From: [Ritzen,Brenda](#)
To: ["Greg Johnson"; Allen,Corey](#)
Cc: [Scott Schneider](#)
Subject: RE: 1290 SKYLINE DR - KEENE #116975
Date: Thursday, March 27, 2025 2:50:00 PM
Attachments: [image001.png](#)

OWNER: RAYMOND & KAY KEENE		DRAWN BY: EJS III / GWJ	
STREET ADDRESS: 1290 SKYLINE DRIVE			
LEGAL DESC: SADDLE BRONC ACRES		UNIT/SECTION/PHASE:	BLOCK: 1
			LOT: 7
PREPARED BY: GREG W. JOHNSON, P.E. F#002585	SCALE: 1"=30'	DATE: 11/14/2023	REVISED: 03/27/2025

RE: Septic Design #116975
1290 SKYLINE DRIVE
SADDLE BRONC ACRES, BLOCK 33, LOT 7
KEENE RESIDENCE

OWNER: RAYMOND & KAY KEENE					DRAWN BY: EJS III		
STREET ADDRESS: 1290 SKYLINE DRIVE							
LEGAL DESC: SADDLE BRONC ACRES				UNIT/SECTION/PHASE:		BLOCK: 1	LOT: 7
PREPARED BY: GREG W. JOHNSON, P.E. F#002585			SCALE: 1"=30'	DATE: 11/14/2023		REVISED: 11/16/2024

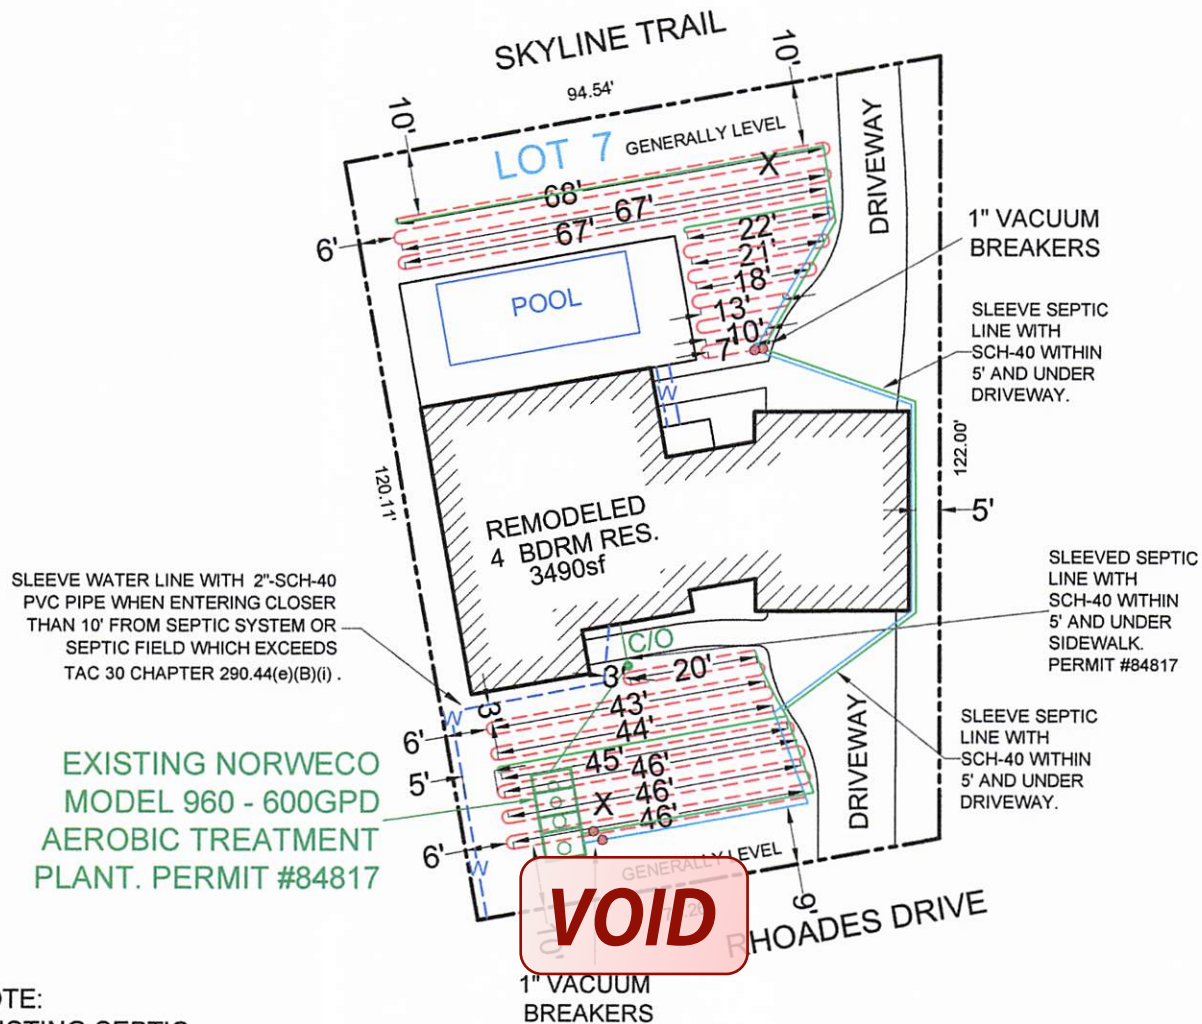
1. ✓ A minimum of 12 inches of soil is required between the bottom of the ATU and the drip tubing.
2. ✓ Submit a variance request for the close proximity of the water line which enters the side of the house. Include the separation distance from this water line to the drip field.
3. ✓ There is also a water line near the clean out that is not shown on the design. Show this water line on the design and its separation distance to the system.
4. Revise as needed and resubmit.

OWNER: RAYMOND & KAY KEENE		DRAWN BY: EJS III	
STREET ADDRESS: 1290 SKYLINE DRIVE			
LEGAL DESC: SADDLE BRONC ACRES	UNIT/SECTION/PHASE:	BLOCK: 1	LOT: 7
PREPARED BY: GREG W. JOHNSON, P.E. F#002585	SCALE: 1"=30'	DATE: 11/14/2023	REVISED:

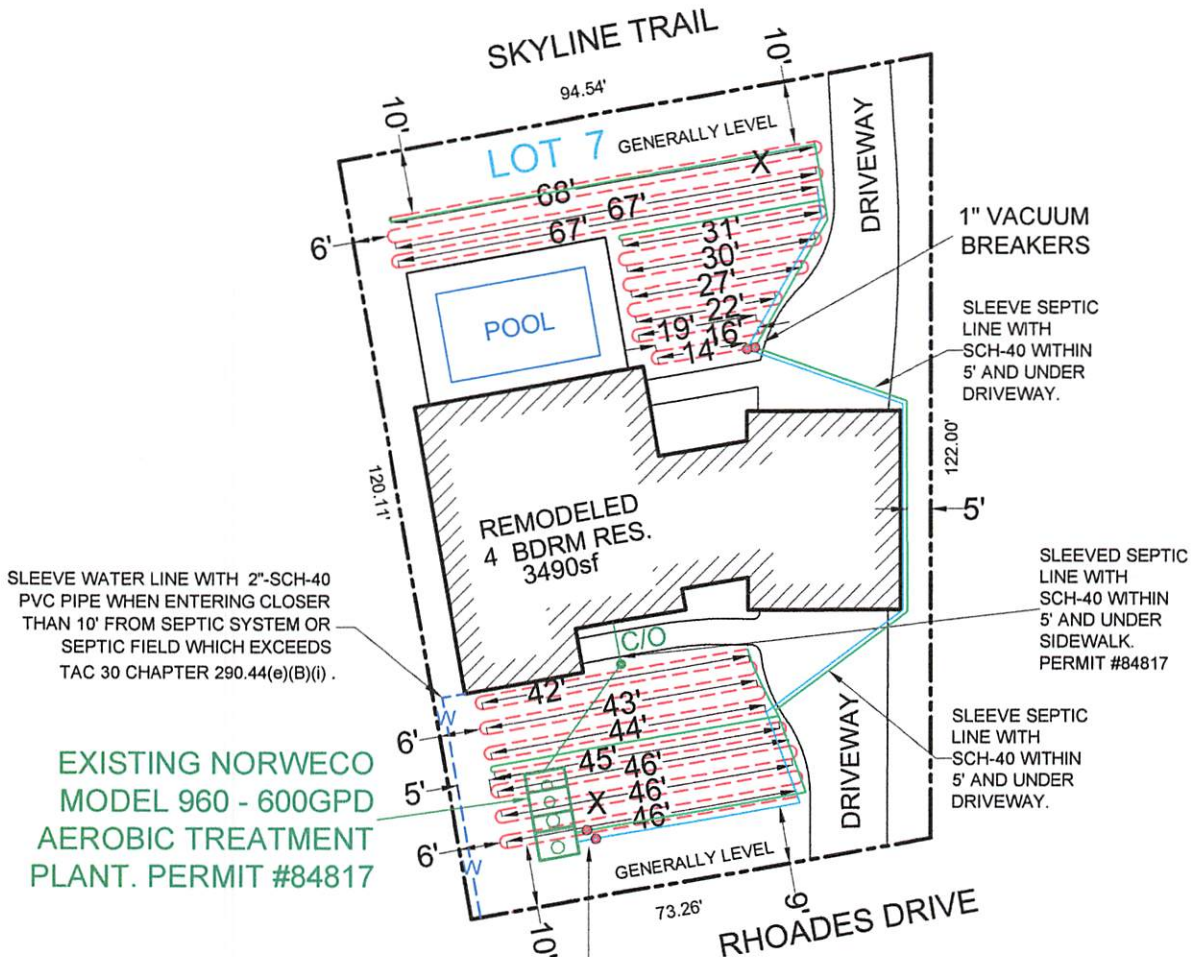
There appears to be a typo on the actual sf. of drip tubing on the attached page. See highlighted on attachment.

Total absorption area: $Q/R_a = 300 \text{ GPD}/0.20 = 1500 \text{ sf.}$ (Actual 2092 sf.)
